**MONTGOMERY COUNTY HISTORIC PRESERVATION COMMISSION**  
**STAFF REPORT**

<b>Address:</b>	3713 Underwood St., Chevy Chase	<b>Meeting Date:</b>	11/15/17
<b>Resource:</b>	Clark House <b>Individually Listed Master Plan Site</b>	<b>Report Date:</b>	11/08/17
<b>Applicant:</b>	Hannah Graae & Duke Schaeffer	<b>Public Notice:</b>	11/01/17
<b>Review:</b>	HAWP	<b>Tax Credit:</b>	partial
<b>Case Number:</b>	35/75-17A	<b>Staff:</b>	Dan Bruechert
<b>Proposal:</b>	Window Replacement, Bay Window Addition, and Door Alteration

Staff recommends that the HPC **approve with conditions** the HAWP application.

EAST ELEVATIONS

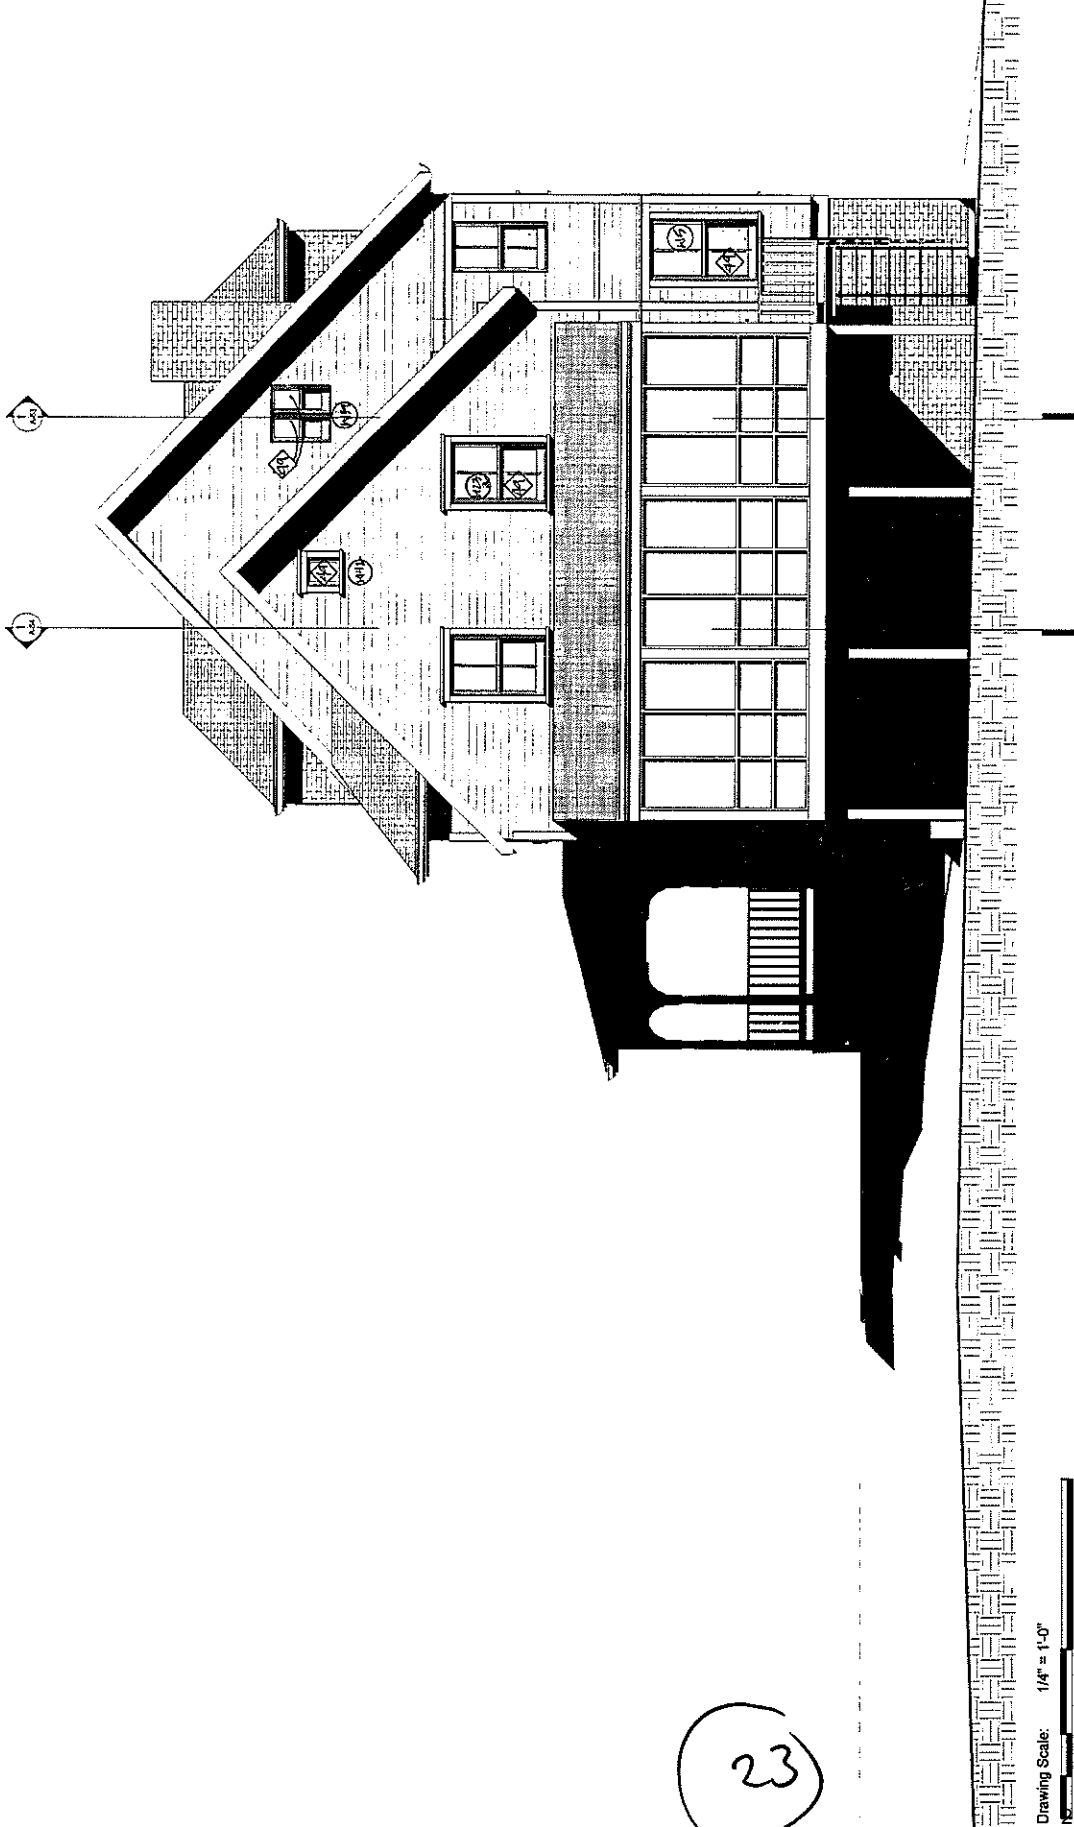
The applicant proposes to construct a bay window in the right side of the house at the rear. The side of the bay will be angled at 45° (forty-five degrees). The angled sides of the bay will have one-over-one aluminum clad sash windows and the central window will be a single-lite picture window. The new windows will be Marvin aluminum clad and the frames and sashes will match the dimensions and appearance of the historic. The exterior details of the proposed bay will match the historic house, with a three-tab hipped roof, matching cornice, and Queen Anne-styled brackets.

To accommodate the construction of the bay two two-over-two sash windows will be removed. The window openings will be filled in using clapboards that match the dimension of the historic siding. Staff feels that because these windows are at the rear of the side elevation their loss will not have a significant impact on the historic character. Additionally, the historic rectangular bay on the right-side elevation will aid in lessening the visual impact of the new bay.

Lastly, one of the two windows has a replacement upper sash which is already showing signs of rot. Were the bay window not proposed, one or both of these windows would need to be replaced due to its physical deterioration. Because of the deterioration of the historic fabric, the compatibility of the design of the proposed bay, and its placement at the back Staff supports approval of the proposed bay window.

*Figure 2: The new bay window will require the removal of the two first-floor windows to the right*
